HISTORIC AND DESIGN REVIEW COMMISSION

August 18, 2021

HDRC CASE NO: 2021-393
ADDRESS: 324 ADAMS ST
LEGAL DESCRIPTION: NCB 946 B-2 LOT SW TRI 12.3 OF 15,16 EXC NE & SW TRI & NE TRI 16.2 FT OF 17 ARB A14
ZONING: RM-4, H
CITY COUNCIL DIST.: 1
DISTRICT: King William Historic District
LANDMARK: Individual Landmark
APPLICANT: dana morgan/davco customom builders
OWNER: niria trevino/MONTOYA LISA J & TREVINO NIRIA
TYPE OF WORK: Installation of a standing seam metal roof with striated panels, parapet wall cap installation
APPLICATION RECEIVED: August 04, 2021
60-DAY REVIEW: Not applicable due to City Council Emergency Orders
CASE MANAGER: Edward Hall
REQUEST:

The applicant is requesting a Certificate of Appropriateness for approval to:

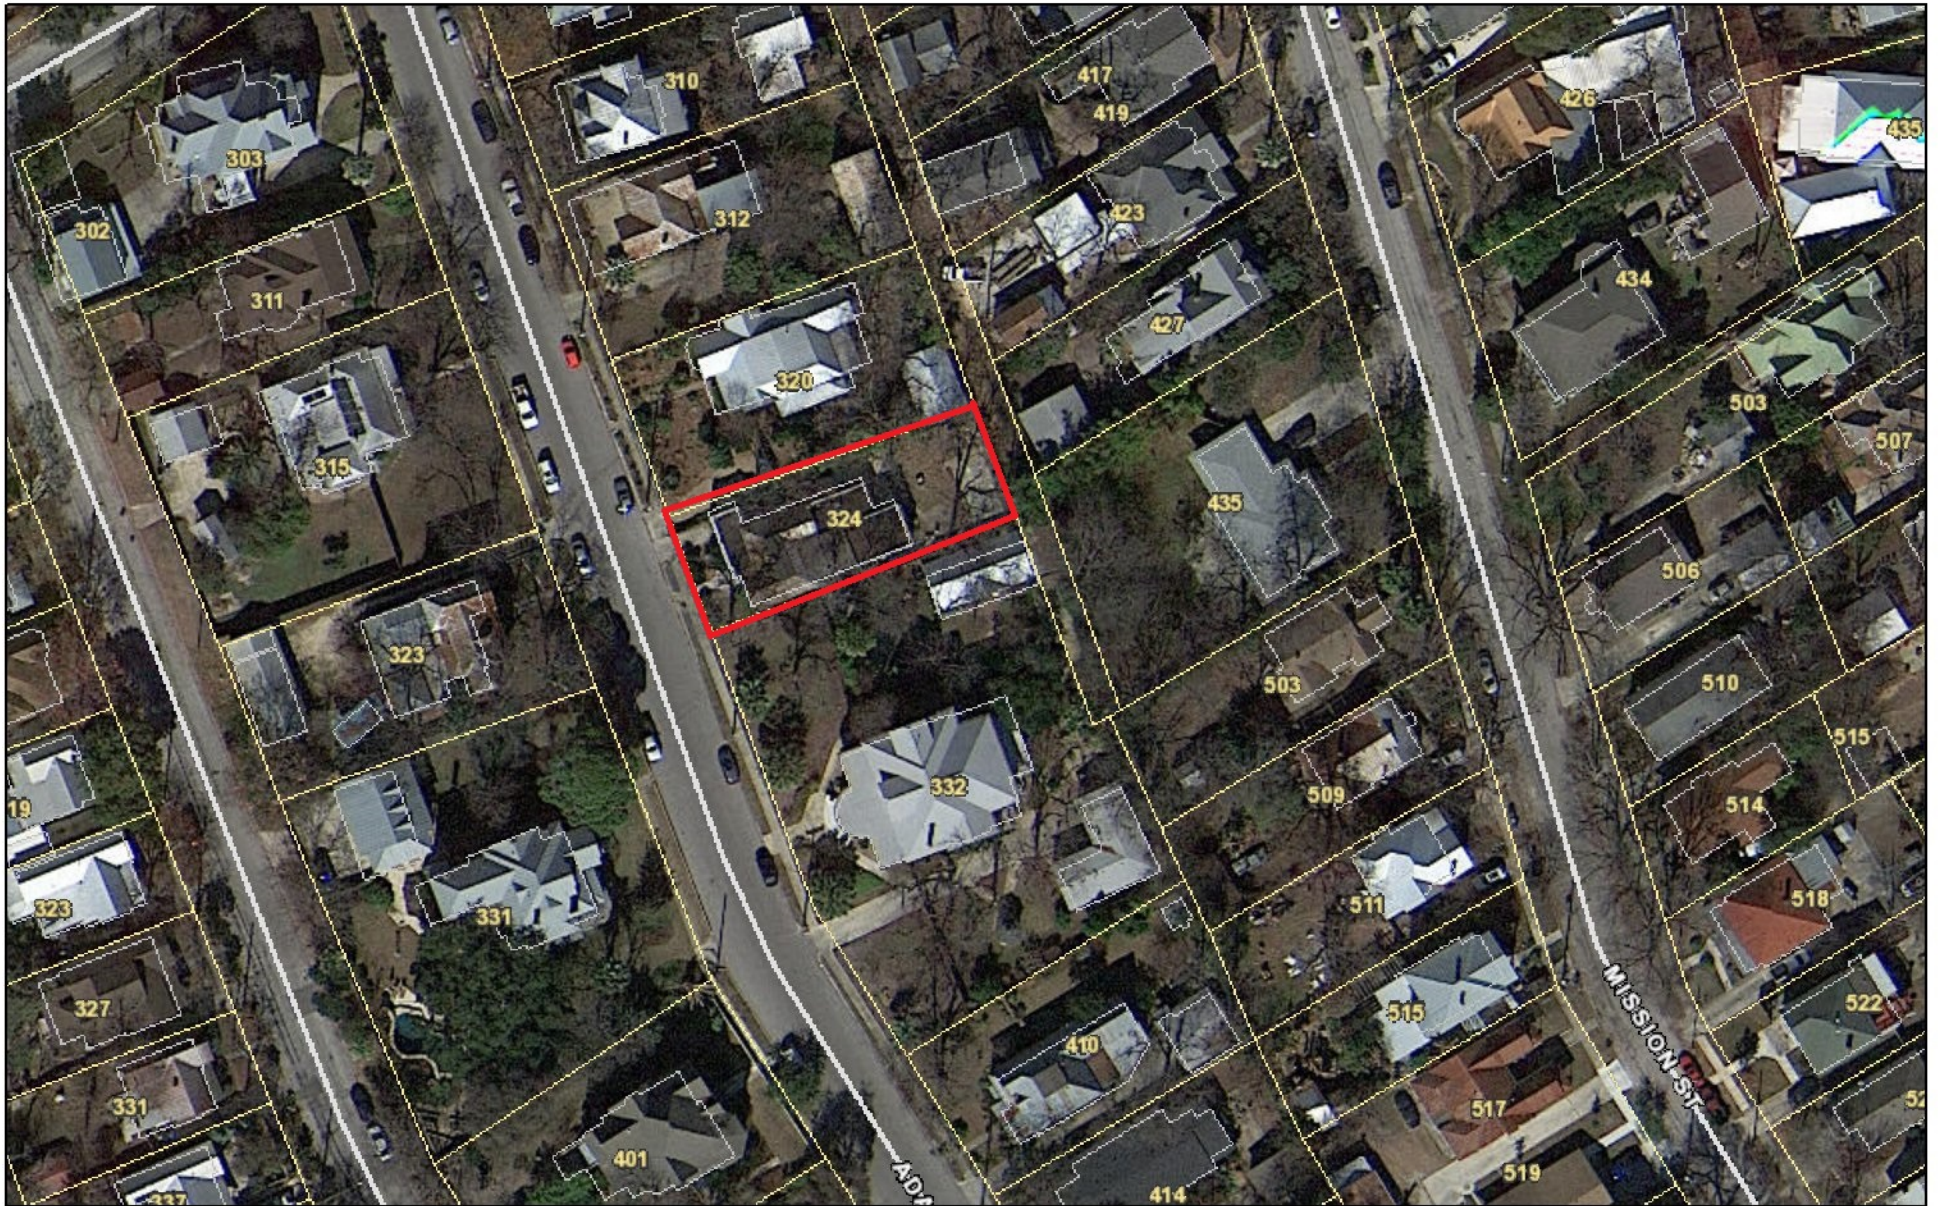
- b. VIOLATION – On July 28, 2021, OHP staff found that a standing seam metal roof had been installed at 324 Adams prior to an on-site materials inspection. The installed roofing materials included standing seam metal roof panels that feature striations and a metal parapet cap on the existing, parapet wall. The requirement for an inspection prior to the installation of roofing materials was noted on the issued Certificate of Appropriateness.

- c. ROOF REPLACEMENT – The applicant has proposed to replace the existing, standing seam metal roof with a new standing seam metal roof to feature panels that are striated. Per the Guidelines for Exterior Maintenance and Alterations 3.B.vi., metal roofs should be installed where historically found or architecturally appropriate. Additionally, the Guidelines note that new metal roofs should adhere to the specifications outlined in the Guidelines; panels should be smooth and feature 18 to 21 inches in width, seams should be 1 to 2 inches tall, ridge seams should feature a crimped ridge seam, and panels should feature a standard galvalume finish. Staff finds the proposed striated panels to be inconsistent with the Guidelines. Staff finds that panels that feature a smooth finish should be installed.

- d. PARAPET CAP INSTALLATION – The applicant has proposed to install a metal parapet cap on top of the existing, parapet walls, to be painted to match the color of the facades. The applicant has noted the installation of a parapet cap top stop current water infiltration into the structure and to prevent further water infiltration into

1. Staff does not recommend approval of item #1, the installation of a standing seam metal roof with striated panels. Staff recommends that the specifications outlined in the Guidelines and the previously issued Certificate of Appropriateness dated June 10, 2021, be adhered to. [The replacement standing seam metal roof must feature panels that are 18 to 21 inches wide, seams that are 1 to 2 inches high, a crimped ridge seam, and a standard galvalume finish. Panels should be smooth without striation or corrugation. Ridges are to feature a double-munch or crimped ridge configuration; no vented ridge caps or end caps are allowed.]
2. Staff recommends approval of the installation of a metal parapet cap on top of the existing, parapet walls. Staff recommends a low profile throughout, as has been installed, and that all parapet caps be painted to match the color of the facades.

Investigation Report

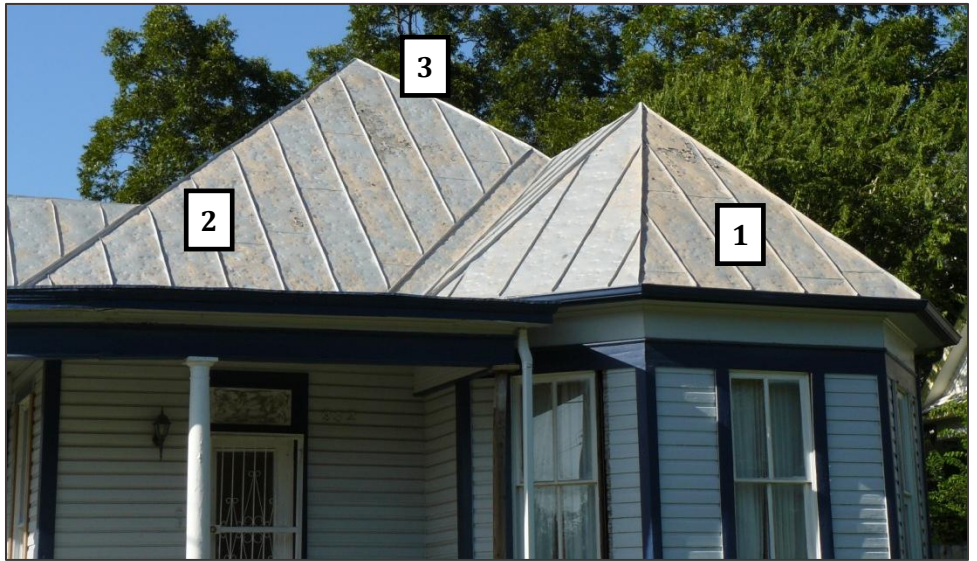
Date	07/28/2021
Time	02:55 PM (-5 GMT)
Context	citizen report
Present Staff	Edward Hall
Present Individuals	Homeowner
Contractor/Realtor Companies	Iron Clad Roofing
Types of Work Observed	Exterior Maintenance and Alterations
Amount of Work Completed	75%
Description of work	Installation of a standing seam metal roof featuring panels with striations and the installation of a parapet cap.
Description of interaction	OHP staff spoke on site with the property owner.

Violation Type	Beyond scope of Certificate of Appropriateness (Code 35-451h)
OHP Action	Spoke with property owner, Posted additional "Stop Work Notice"
Will post-work application fee apply?	To be determined
